October 31, 2018

Subject: Work Plan Approval for Site Cleanup Program Case Number RO0003163 and GeoTracker Global ID T10000006546, Elegant Cleaners, 1208 Lincoln Avenue, Alameda, CA

Figure
5

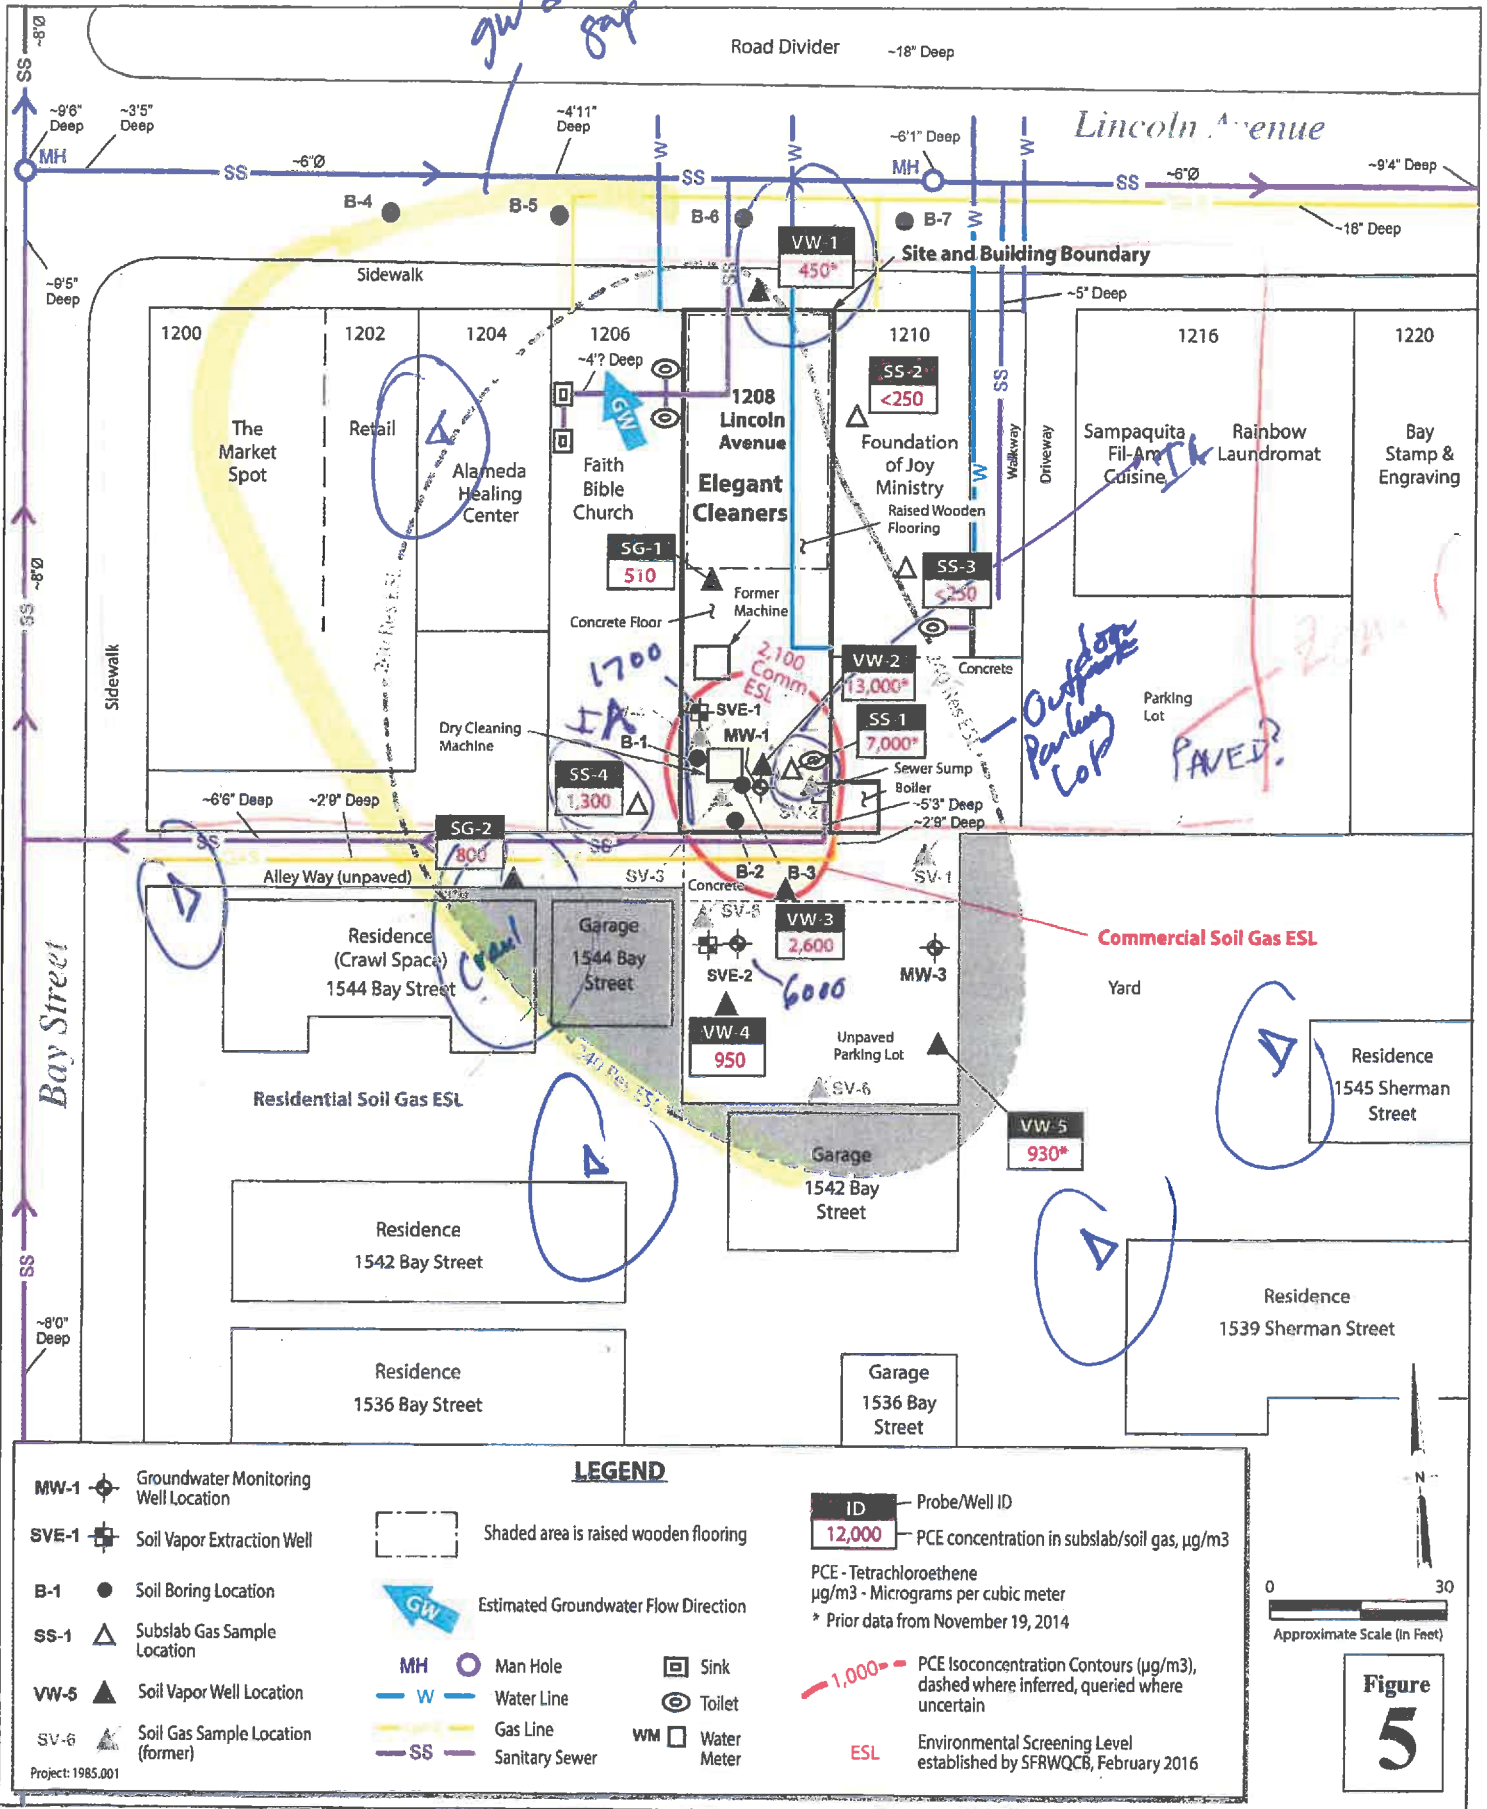
The Elegant Cleaners source area for groundwater and vapor appears to be located in the rear of the Elegant Cleaners building, the location of the dry cleaner machine, and behind the building in the unpaved parking lot. The Report's attached Figure 4, *PCE in Groundwater March 2017*, and Figure 5, *PCE in Subslab/Soil Gas, March 2017*, documented the existence of tetrachloroethene (PCE) in both groundwater and soil vapor on-and off-site. Three site groundwater monitoring wells located in the unpaved parking lot behind the Elegant Cleaners building detected a maximum of 43 ug/L PCE in April 2016. Grab groundwater samples B-4 through B-7 were collected in Lincoln Avenue; B-5 detected 360 micrograms per liter (ug/L) PCE. The extent of PCE in groundwater is undefined to the west and east of the source area, beneath the contiguous store front businesses on either side of the Elegant Cleaners building.

- a. Compare and overlay the Report's Figure 4, *PCE in Groundwater March 2017*, and Figure 5, *PCE in Subslab/Soil Gas* and calculate estimated groundwater concentrations;
